July 2017 Product Shipping Configuration Change Notice

Engineering Advisory 124139

3725-47130-005

VVX 600 Console Label and Revision Code

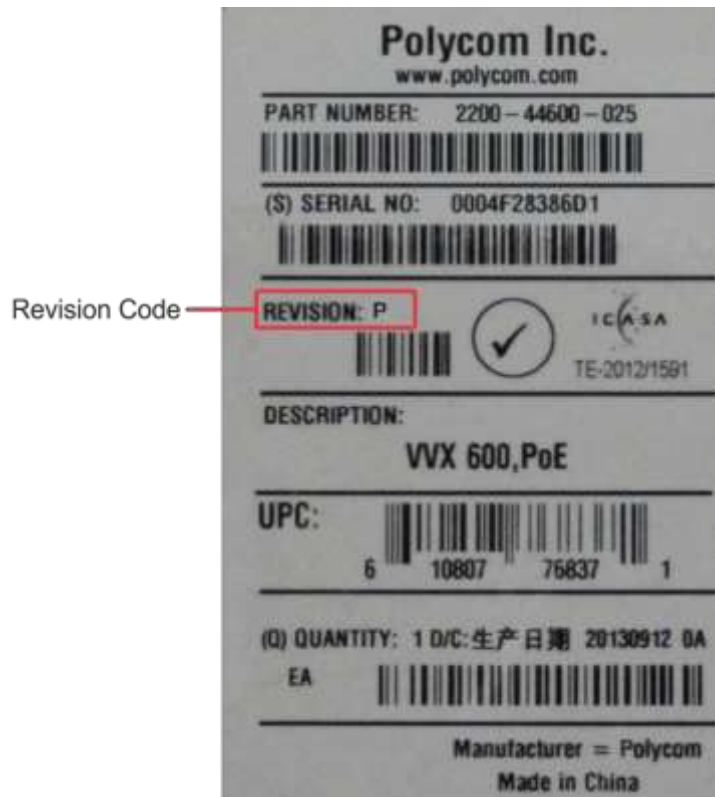
You can determine whether your phone includes the new software by examining the date code listed on back of the phone and on the shipping boxes, as shown in the following two example figures [VVX 600 Console Label and Revision Code](#) and [VVX 600 Shipping Box Label and Revision Code](#). This notice will be updated to reflect the actual codes as information becomes available.

Note that in the two figures the date code starts with the following Chinese characters 生产日期 followed by the date code format YYYYMMDDL, indicating when the phone was built. (The suffix LL indicates the manufacture location.)
